Access Compliance Report

Public Rights-of-Way

(Curb Ramps)

Intersection ID: 25942	Main Street: ELM_LN	Cross Street: OLD_WELL_HOUSE_RD	Location: N
ADA ID: 6EE05E37A321	Ramp Type: Perp	Initial Pass/Fail: Fail	Overall Compliance: No
Severity Score: 21.25			
Codes/Mitigation Info/Possible Solution		Field Measurements/Component Compliance

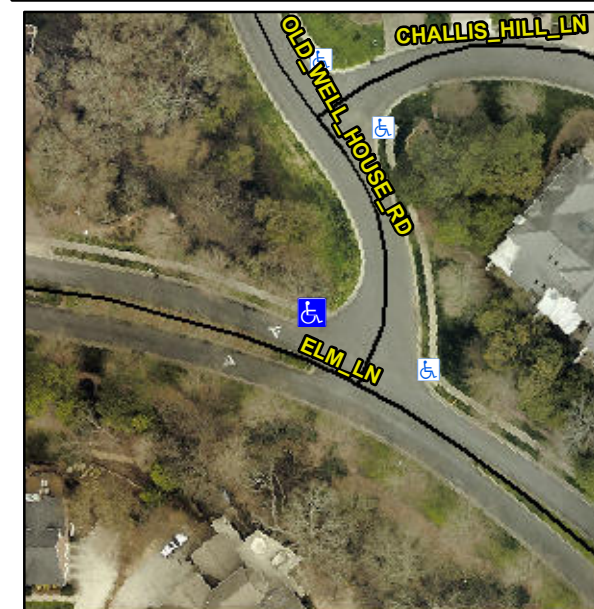
Not Found, R304.5.1, R304.2.2

Compliance	Description	Data	Compliance	Description	Data
N/A	Ramp Length (in)	84.0	No	Ramp Slope (%)	9.3
No	Ramp Width (in)	46.0	Yes	Ramp XSlope (%)	0.0
N/A	Flare Type LT	N/A	N/A	Flare Type RT	N/A
N/A	Flare Slope LT (%)	N/A	N/A	Flare Slope RT (%)	N/A
N/A	Flare Traversable LT?	N/A	N/A	Flare Traversable RT?	N/A
N/A	Landing Length (in)	N/A	N/A	DWS Provided?	N/A
N/A	Landing Width (in)	N/A	N/A	DWS Contrast?	N/A
N/A	Landing Slope (%)	N/A	N/A	DWS Length (in)	N/A
N/A	Landing X Slope (%)	N/A	N/A	DWS Full Width?	N/A
N/A	Landing Curb? (Y/N)	N/A	N/A	DWS Offset (in)	N/A
N/A	Shared Landing?	N/A			
N/A	Gutter Ponding?	N/A	N/A	Gutter Slope (%)	N/A
N/A	Gutter Lip Ht (in)	N/A	N/A	Gutter X Slope (%)	N/A
N/A	Painted X Walk1?	No	N/A	Painted X Walk2?	N/A
	X Walk 1 Direction	To SE		X Walk 2 Direction	N/A
N/A	X Walk 1 Width (in)	N/A	N/A	X Walk 2 Width (in)	N/A
	X Walk 1 Slope (%)	4.7		X Walk 2 Slope (%)	N/A
	X Walk 1 X Slope (%)	3.3		X Walk 2 X Slope (%)	N/A

Remove & Replace Entire Ramp.
